## ADDENDUM No. 3

## ITB No. 4660

# **Argo Livery Restroom and Site Improvements**

Sheet 14Remove and replace Sheet 14 Site Details as updated herin.Comment: The intent of this change is to update the asphalt details.

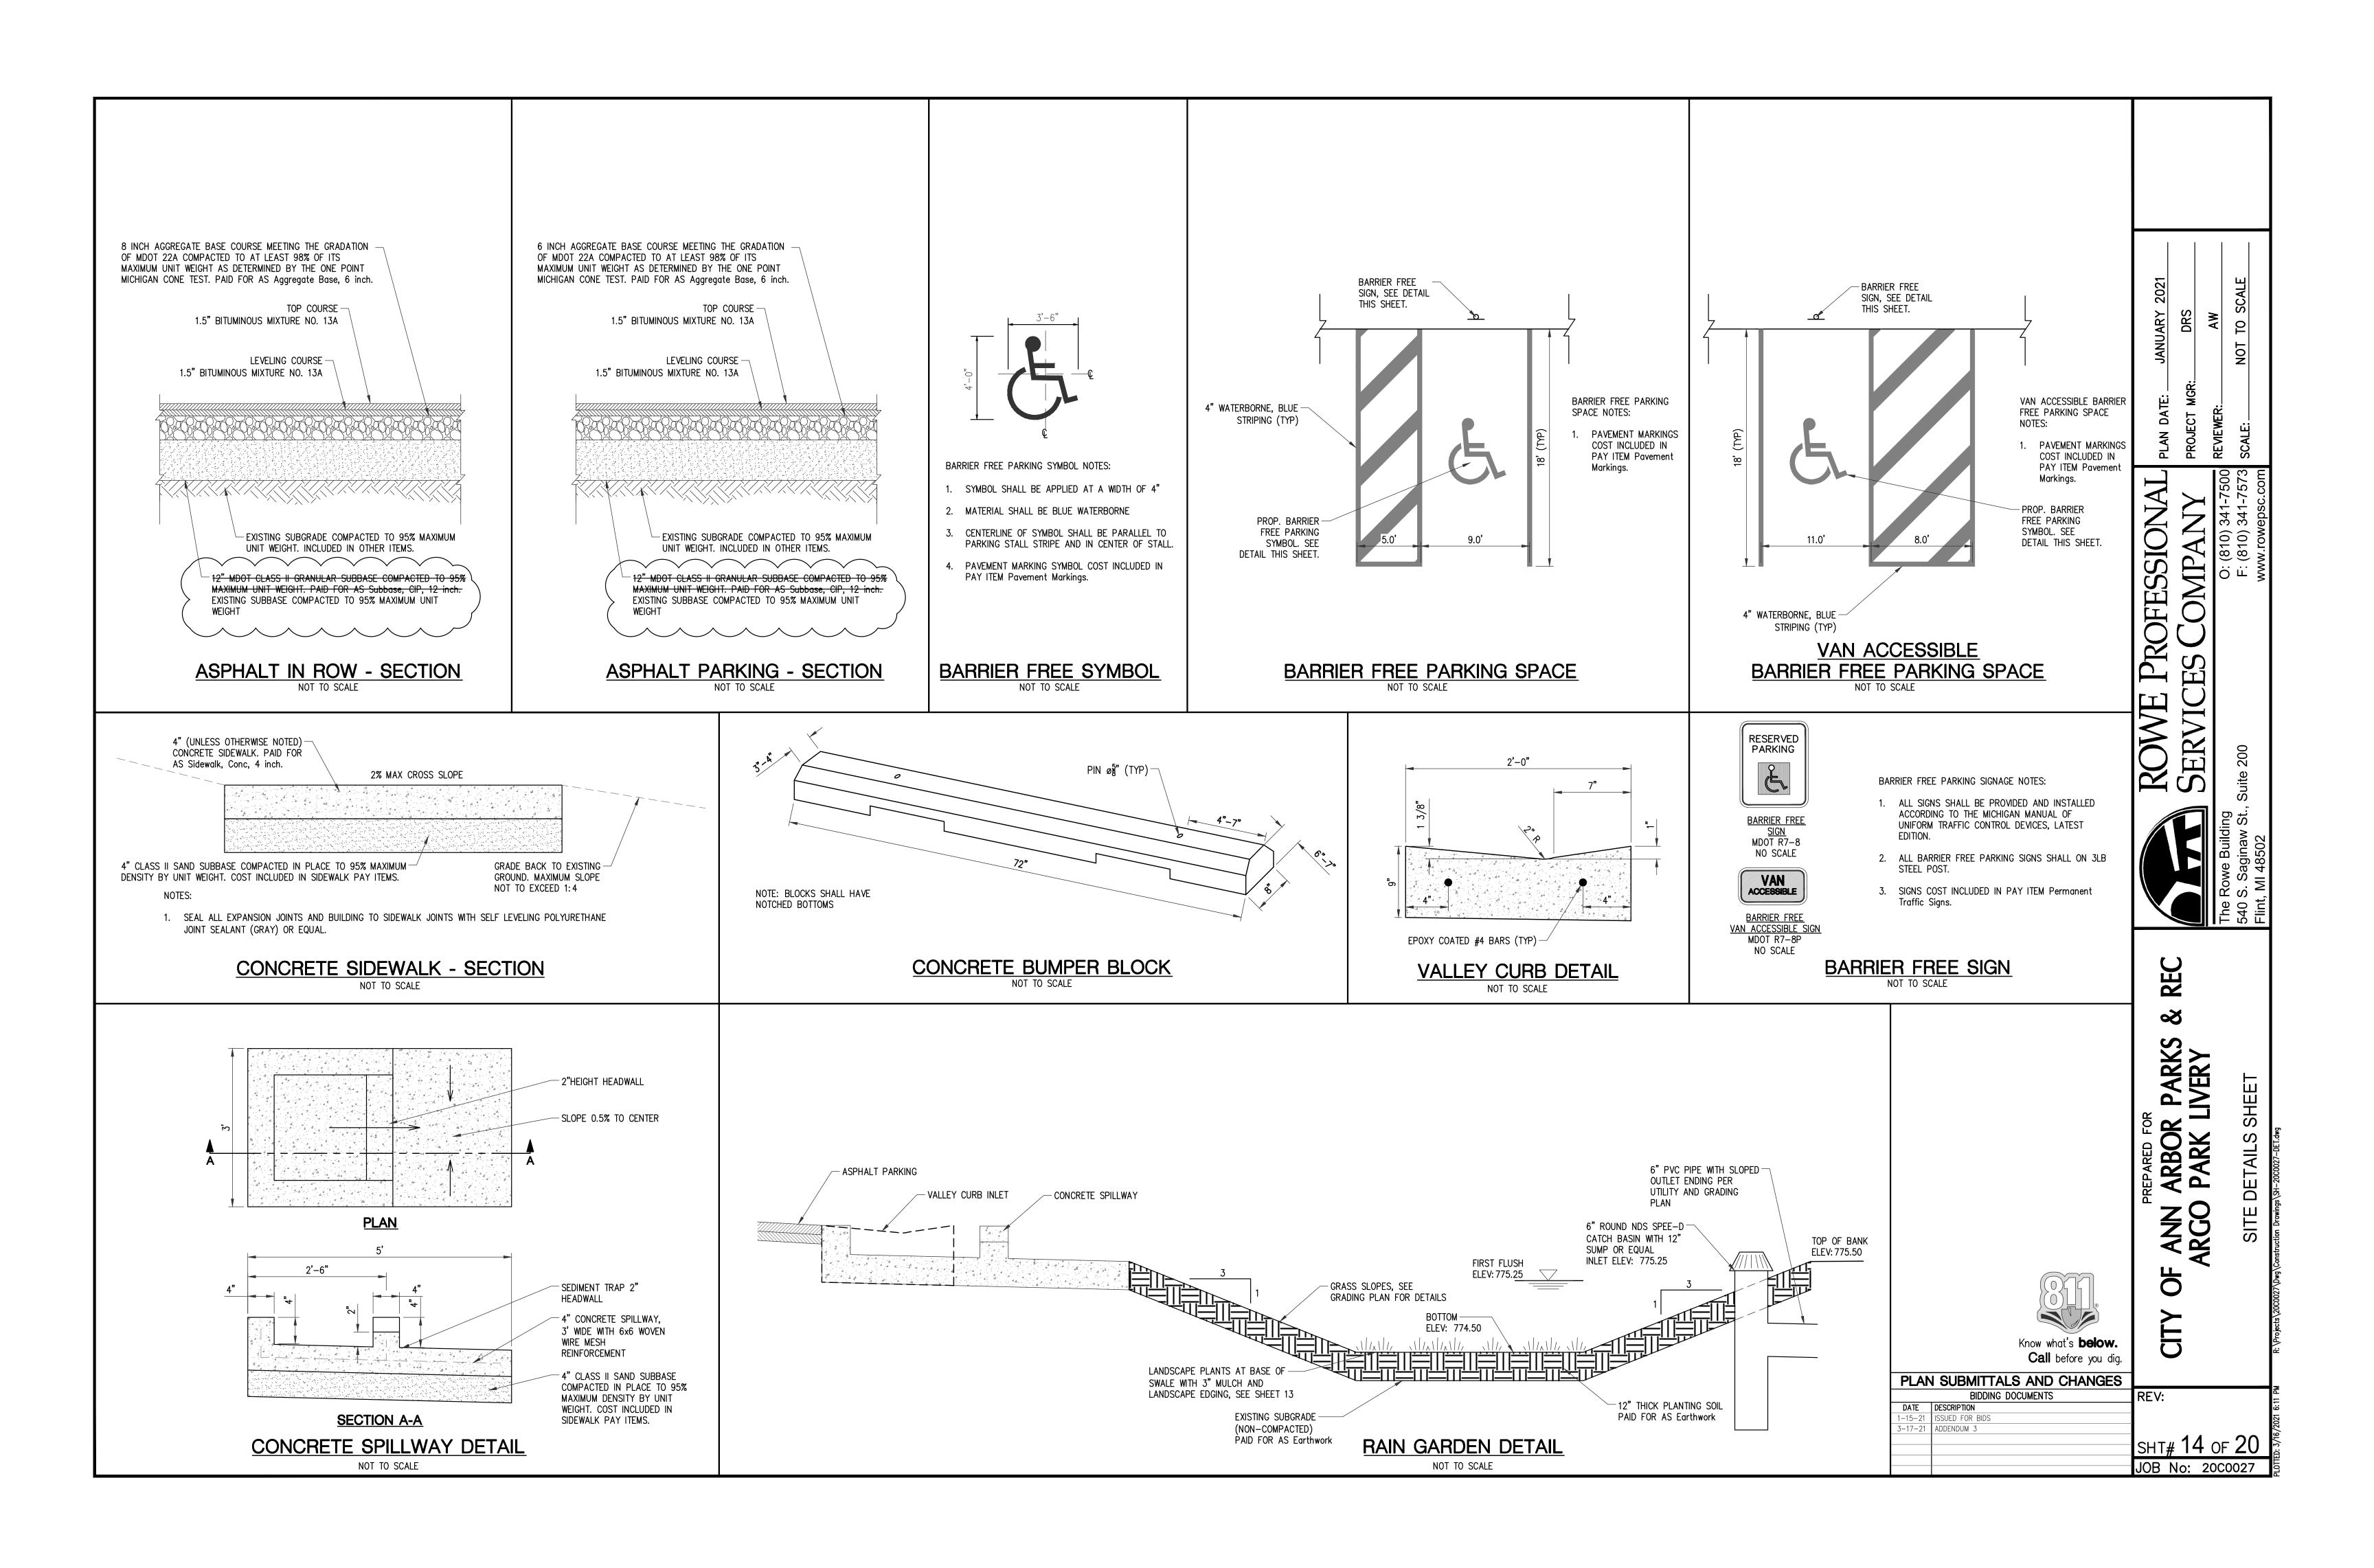
**Question 1:** On Sheet 14 of 20, SITE DETAILS SHEET, both asphalt details call for "12" MDOT Class II Granular subbase compacted to 95% maximum unit weight, paid for as Subbase, CIP, 12 inch". Is this material necessary in this pavement section? There is also no "Subbase, CIP, 12 inch" pay item. Just asking for clarification on the asphalt pavement section.

**Answer 1:** Payment for Subbase, CIP 12 inch is not expected. Existing subbase material appears to be sufficient based on the soil borings.
